# Staff Summary Report

SUBJECT: Hold a public hearing for a Use Permit and Development Plan Review for Emmanuel

Lutheran School located at 715 W. Southern Avenue.

COMMENTS: Request for EMMANUEL LUTHERAN SCHOOL (PL090095) (Kirk Jungbluth, Emmanuel

ATTACHMENT 8

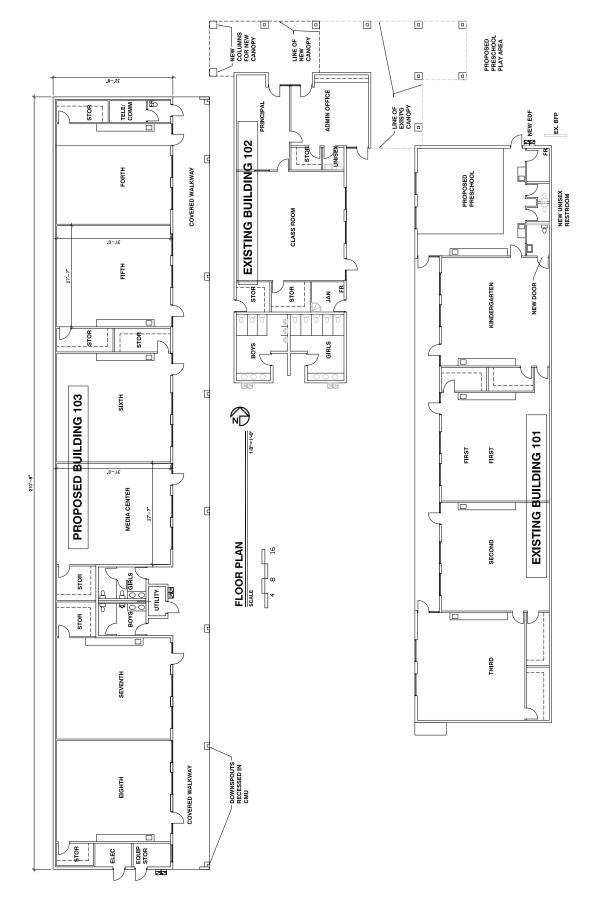
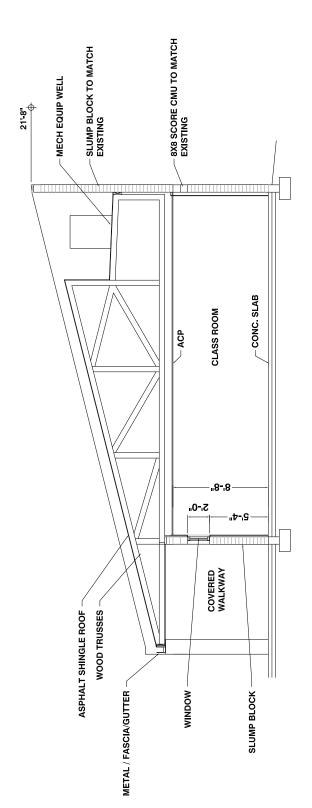
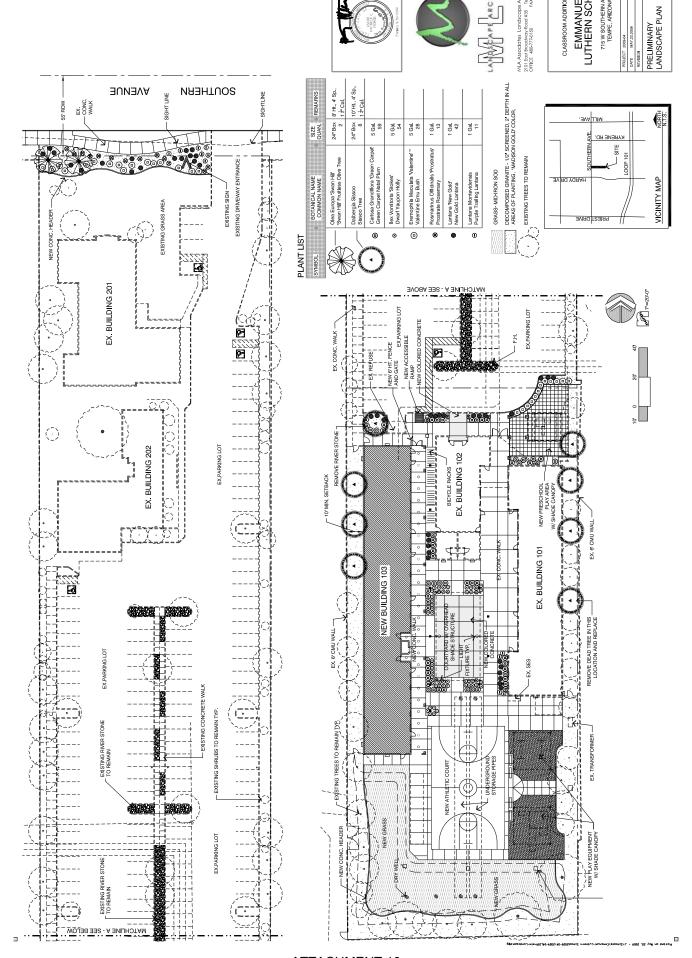
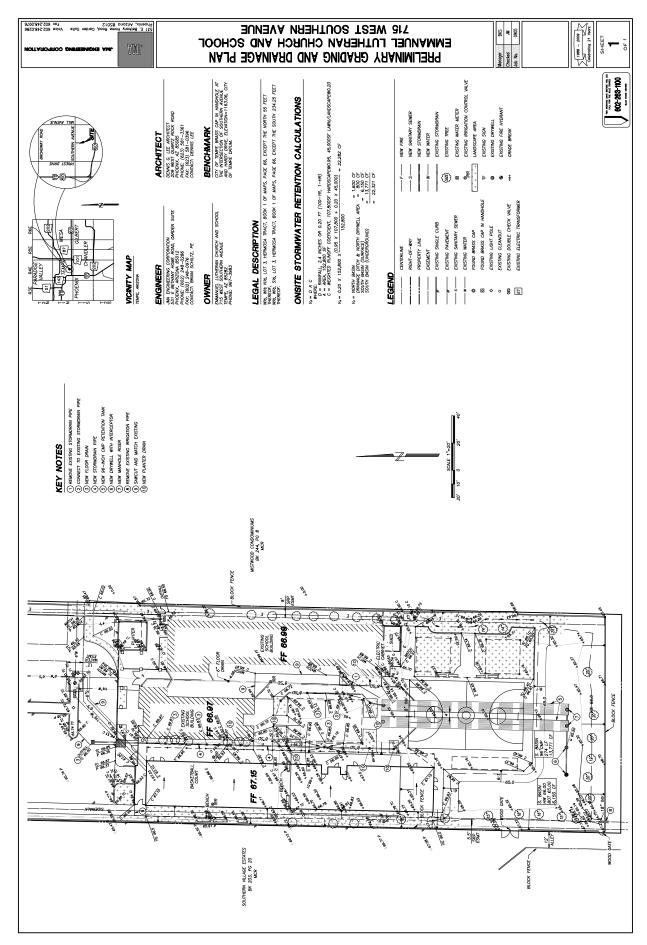
16. The materials and colors are approved as presented:

Colored Concrete (courtyard/admin. Entry) – Sequoia Sand (taupe color) by Davis

Slump Block (painted to match existing) – DE6122 Dry Creek (beige color ) by Dunn Edwards

Asphalt Shingles (match existing) – Beachwood by Owens Corning

8x8 Scored CMU, wood beams, trellis, metal fascia, gutters & downspouts painted – DE6125 Carved Wood (light brown) by Dunn Edwards

Metal Canopy & Shade Poles painted – DE5397 Radiant Sunrise (bright yellow) by Dunn Edwards

HM Doors and Frames painted – DE5845 Americana (bright blue) by Dunn Edwards

Main colors and materials all have a light reflectance value of 75 percent or less. Specific colors and materials exhibited on the materials sample board are approved by planning staff. Submit any additions or modifications for review during building plan check process.
